Docket Number:	06-AFC-09C
Project Title:	Colusa Generating Station - Compliance
TN #:	212004
Document Title:	Pacific Gas & Electric Company's Petition for Amendment for Colusa Generating Station
Description:	N/A
Filer:	Marie Fleming
Organization:	DayZen LLC
Submitter Role:	Applicant Representative
Submission Date:	6/28/2016 12:27:37 PM
Docketed Date:	6/28/2016

**Subject: PACIFIC GAS AND ELECTRIC COMPANY'S PETITION FOR
AMENDMENT
COLUSA GENERATING STATION
DOCKET NO. (06-AFC-9C)**

PETITION TO AMEND

COLUSA GENERATING STATION (06-AFC-9C)

FIGURE 2-1

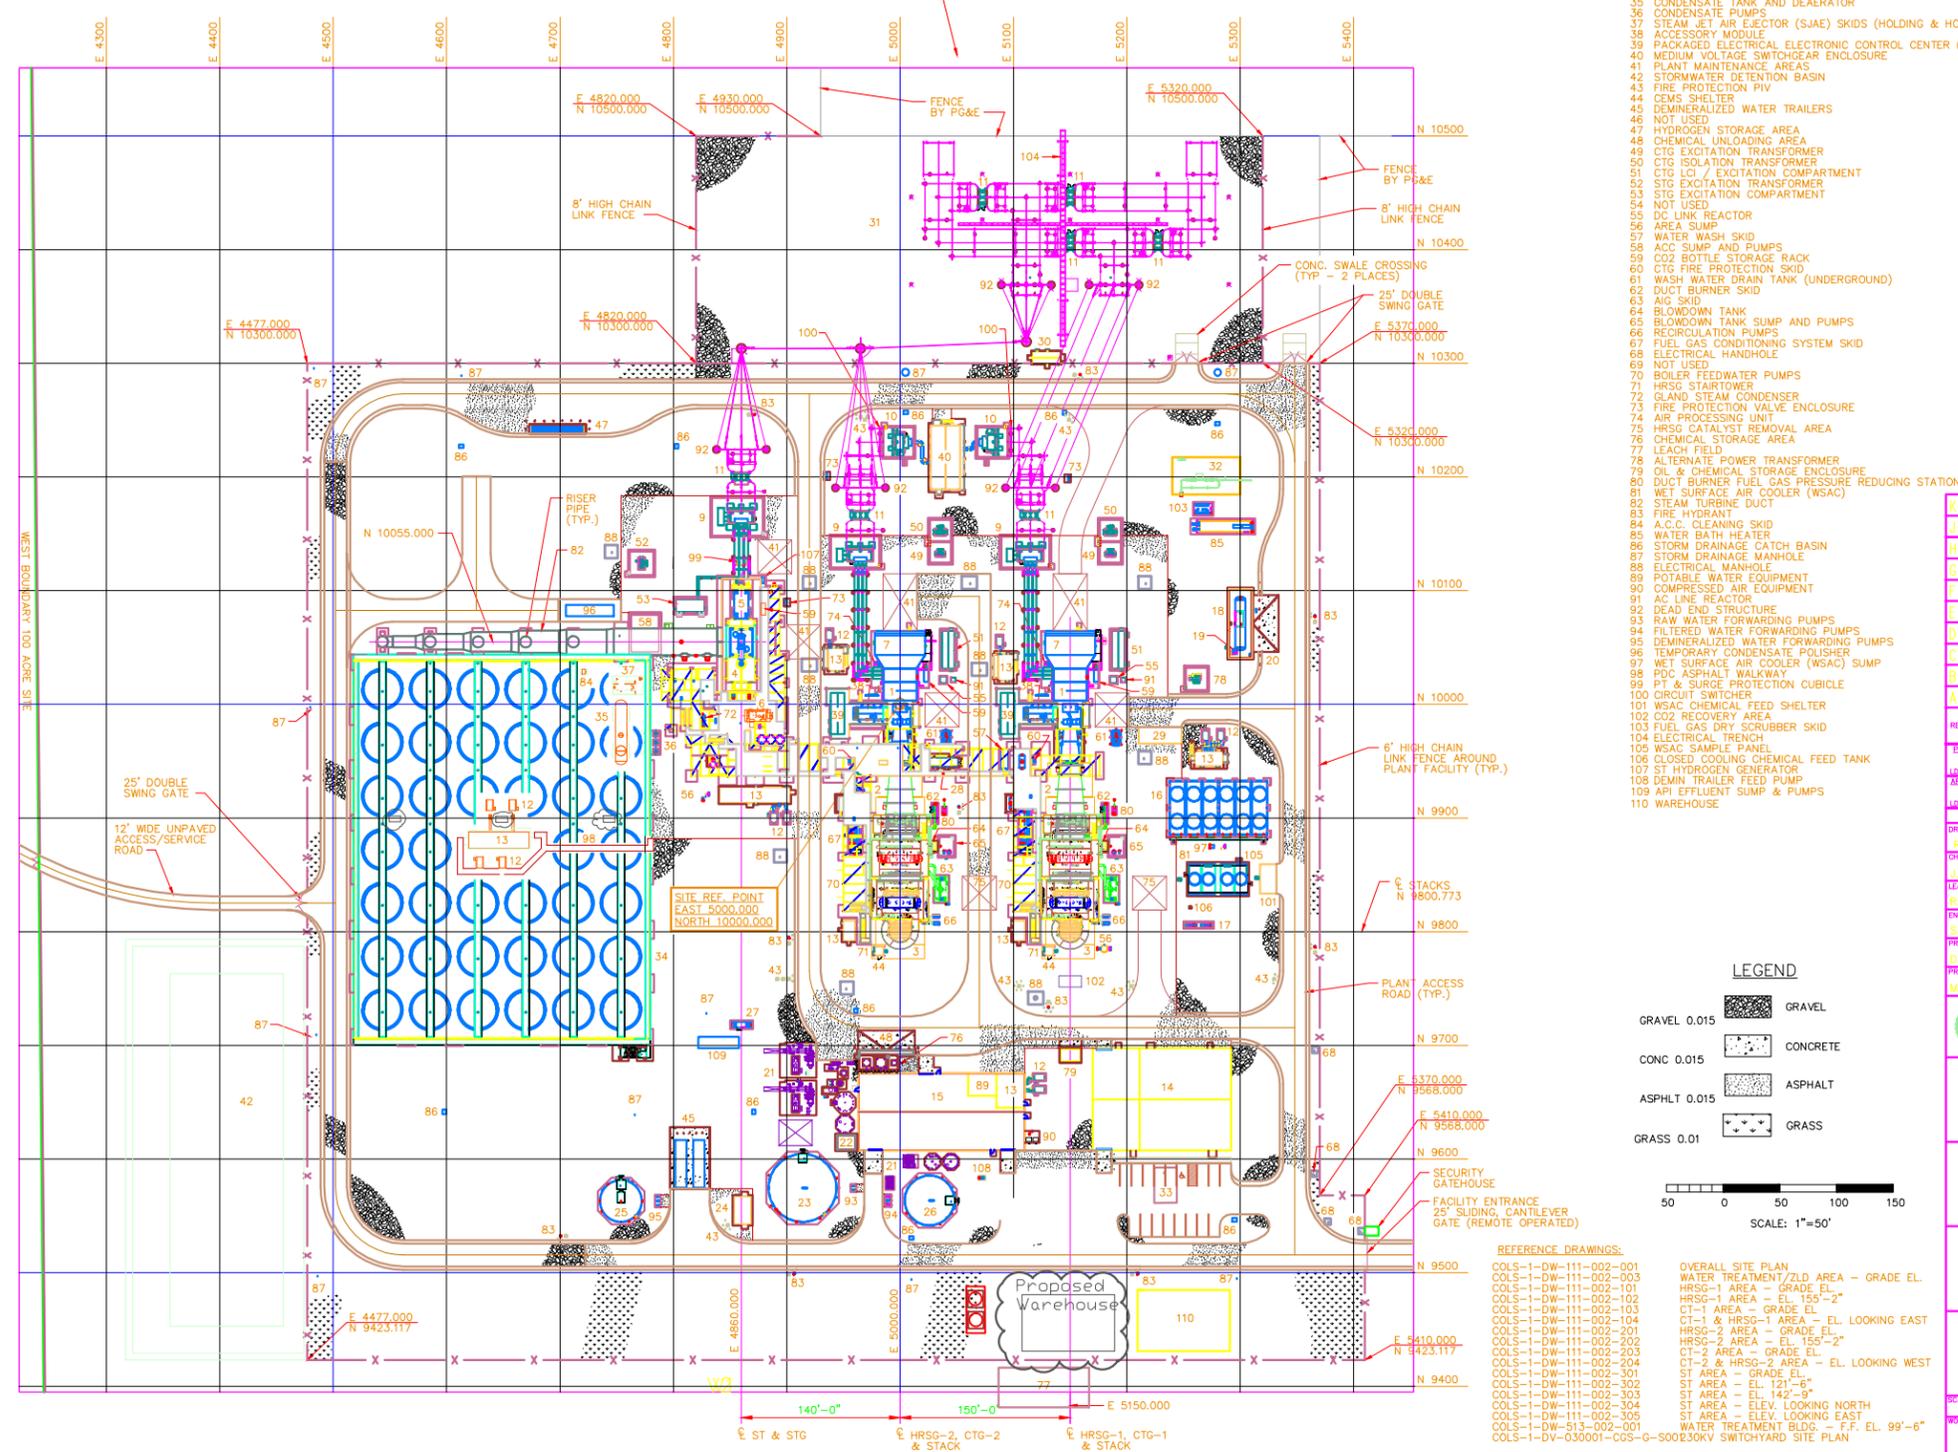
The proposed new warehouse will be constructed 30 feet to the west of the existing warehouse which is currently located in the southeast corner of the CGS site. It will be approximately 65 feet by 110 feet and approximately 24 feet tall. The warehouse will have a roof interconnection to the existing warehouse to allow for covered storage. It will be constructed on spread footings with a concrete slab on grade. The building will utilize standard metal I-beam construction with metal-clad walls and will be constructed with materials and methods similar to the existing adjacent warehouse.

Figure 2-1, General Arrangement and Site Plan shows the proposed location of the new warehouse. This location consists of land that was previously graded during the construction of the CGS. Figures 2-2 and 2-3 depict the relative size of the new warehouse in relation to the surrounding structures.
